Ref: P210203/so'r

RE: EQUINIX (IRELAND) LTD.,
PLOT 100, PROFILE PARK, NANGOR ROAD, CLONDALKIN, DUBLIN 22,
PLANNING REG. REF. SD21A/0186

Please find our response to Item No.'s 4 & 6, addressing the Request For Additional Information pertaining to the above project, as dated 30th August 2021, together with 6 No. copies of all documentation, as mentioned below:-

Drawing Number:
 DB080-PIN-00-ZZ-DR-C-PLAN-1212

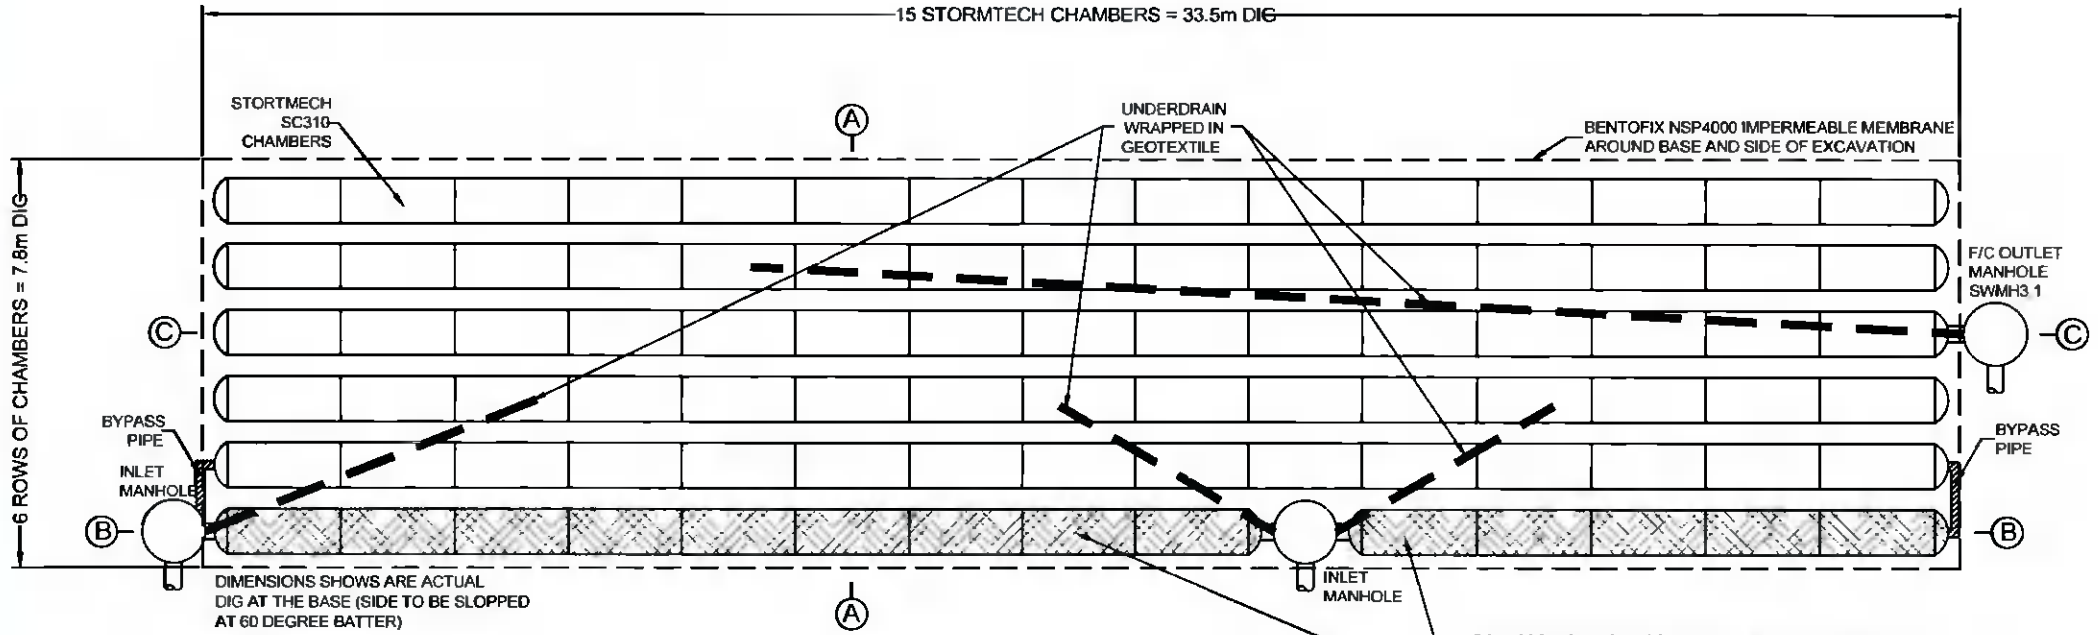
(a) The applicant is requested to submit a report showing greenfield run off rates and attenuation calculations for each surface water drainage catchment. The report shall include a breakdown of all surface types and run off coefficients for each surface water catchment area.

Please see Drawing DB080-PIN-00-ZZ-DR-C-PLAN-1212-External Works Plan attached in Annexure E showing the surface areas and catchments.

SITE: EQUINIX - PROFILE PARK, LUCAN, TANK 1 120m3	JN210609 DRAWING NO.	1 PAGE NO.	28/07/21 DATE.	
TITLE: PLAN	NTS SCALE	LP DRAWN.	LP CHECKED.

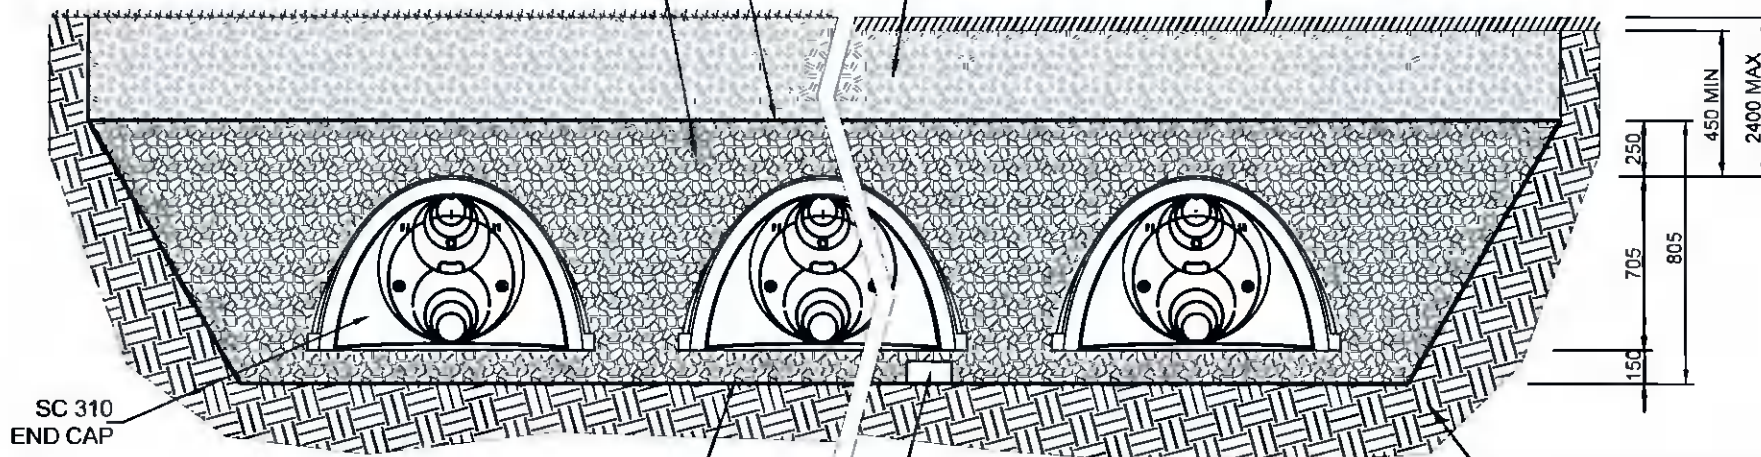
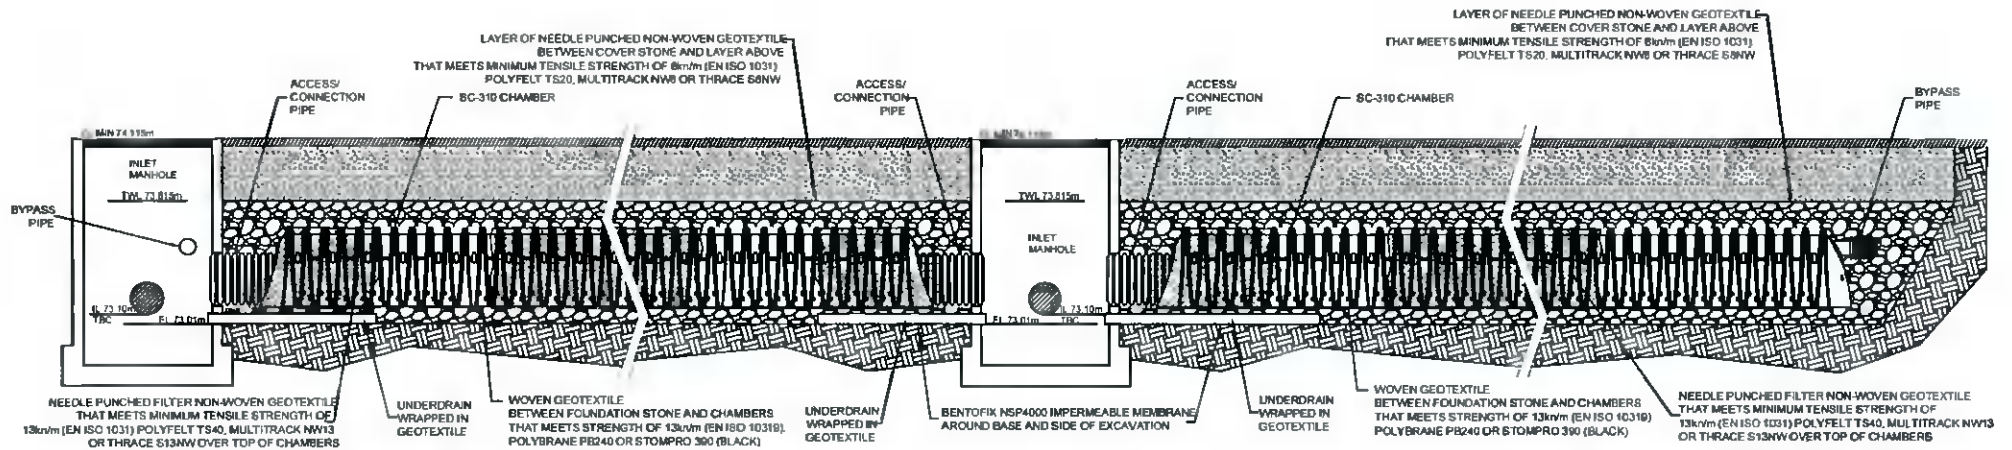
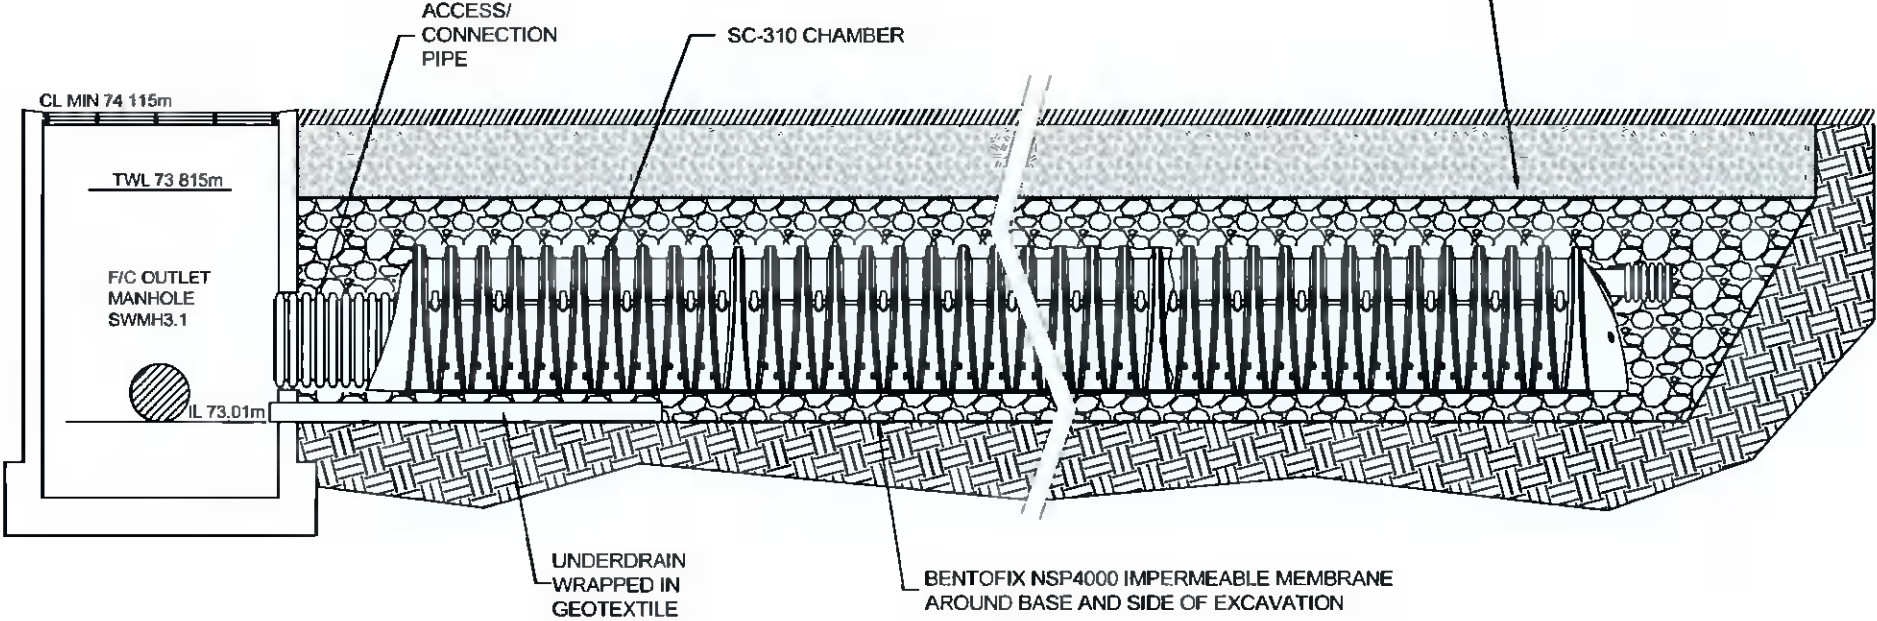
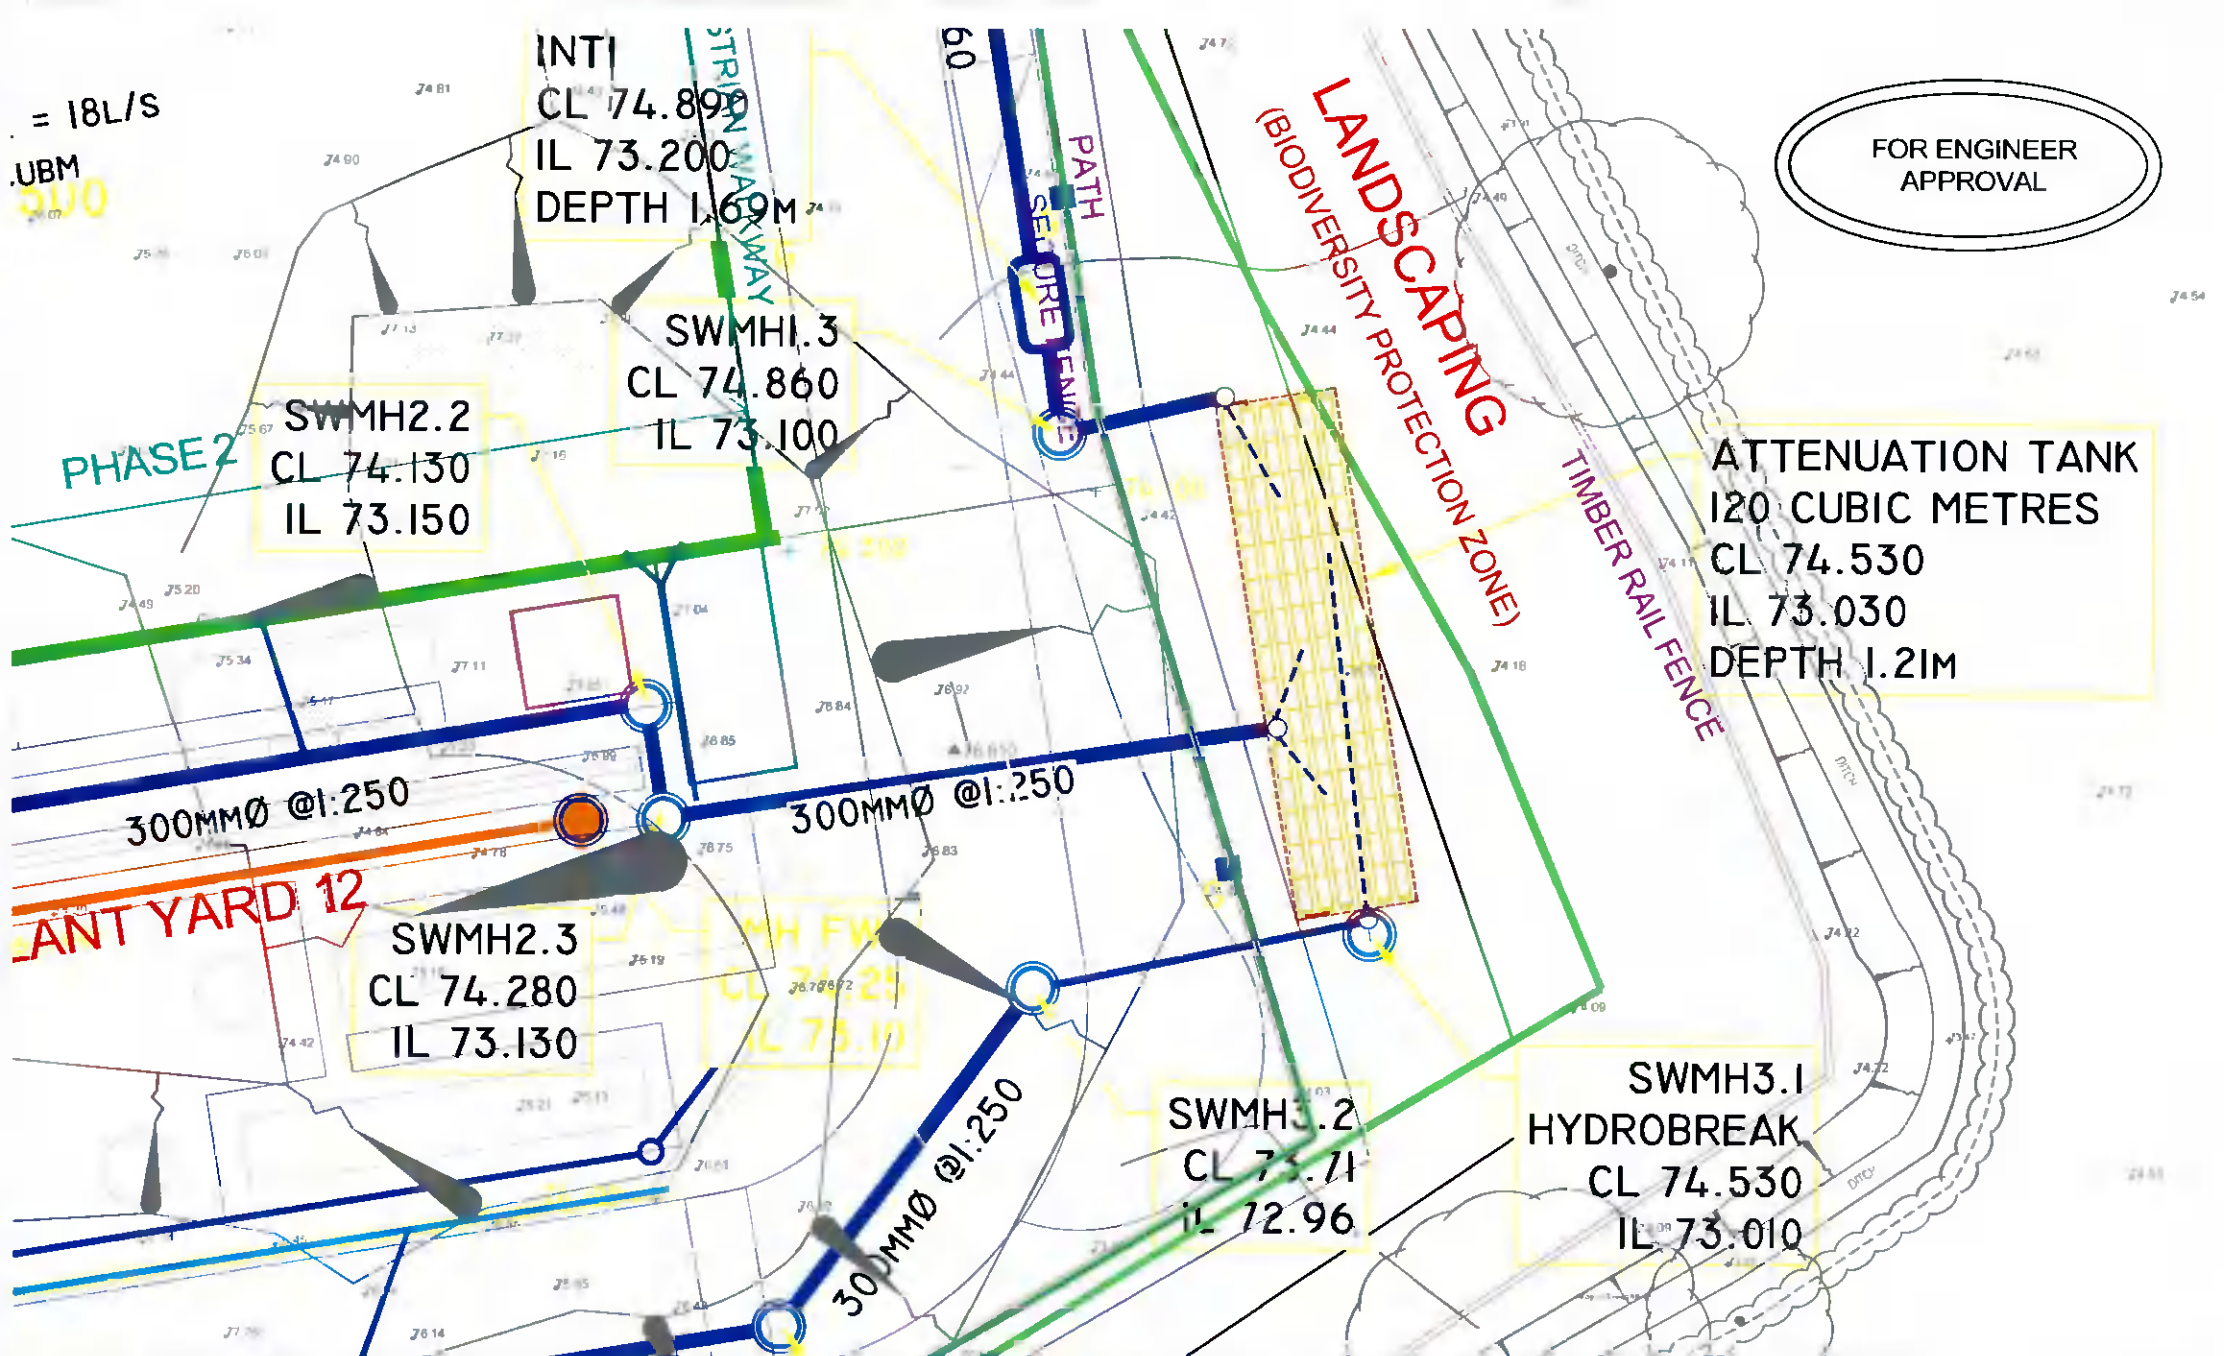
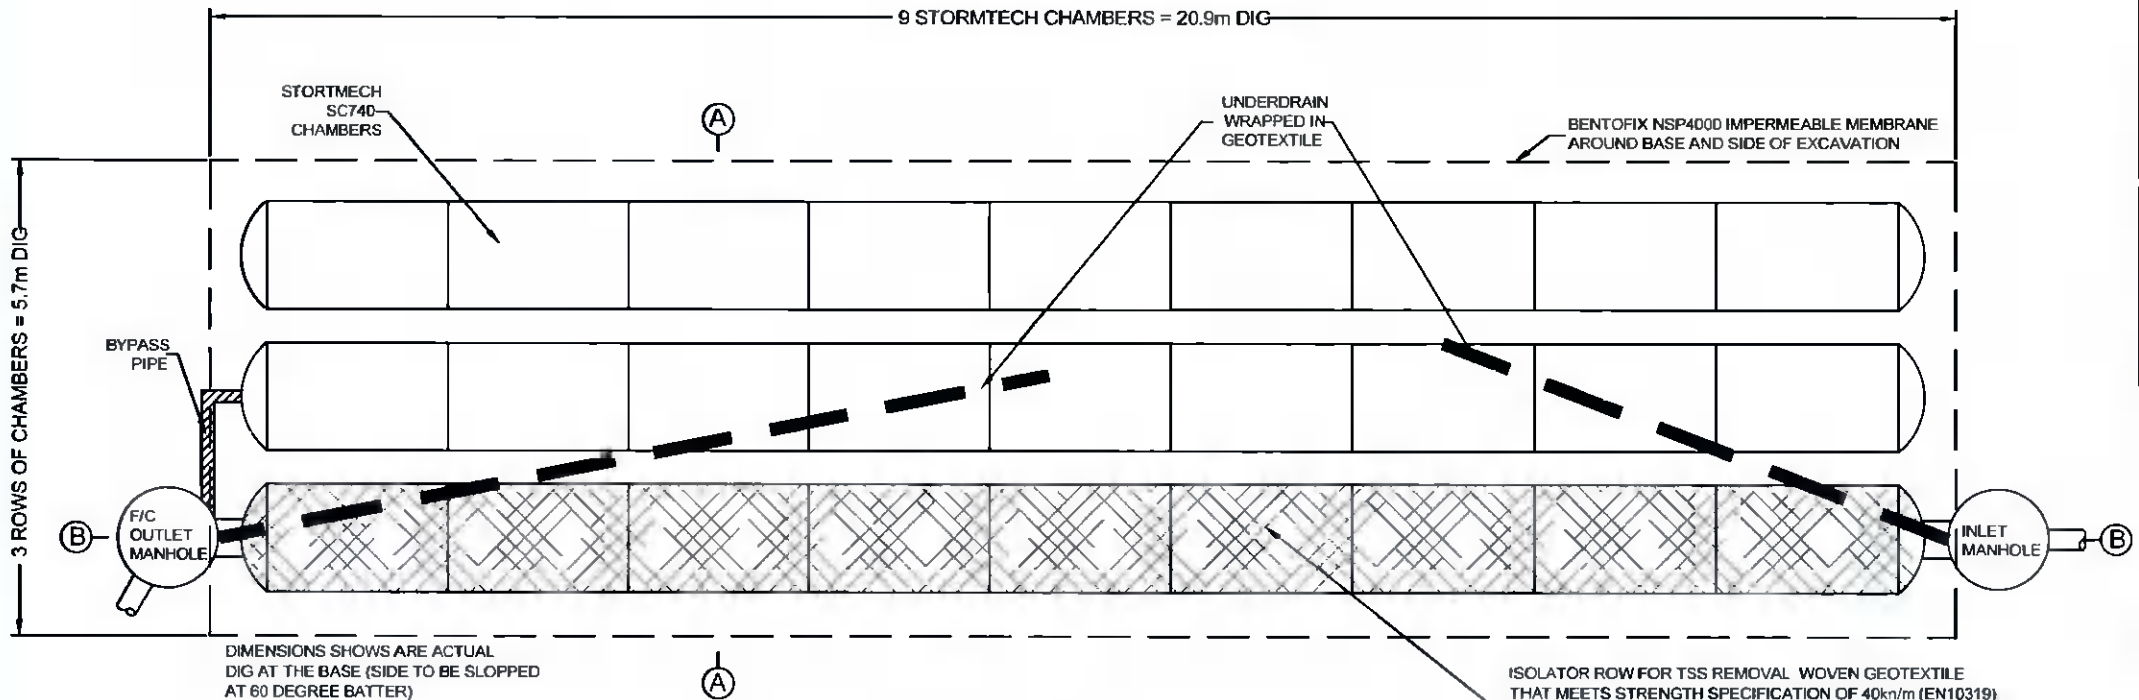
(c) The applicant is requested to minimise the use of underground attenuation systems on site. Where this cannot be achieved arch type systems should be installed as oppose to concrete tanks. The applicant is requested to submit a cross section detail of the proposed attenuation pond and underground attenuation systems.

Attenuation Tank 1 and Attenuation Tank 3 will be a Stormtech attenuation tanks, please see details attached in Annexure F.
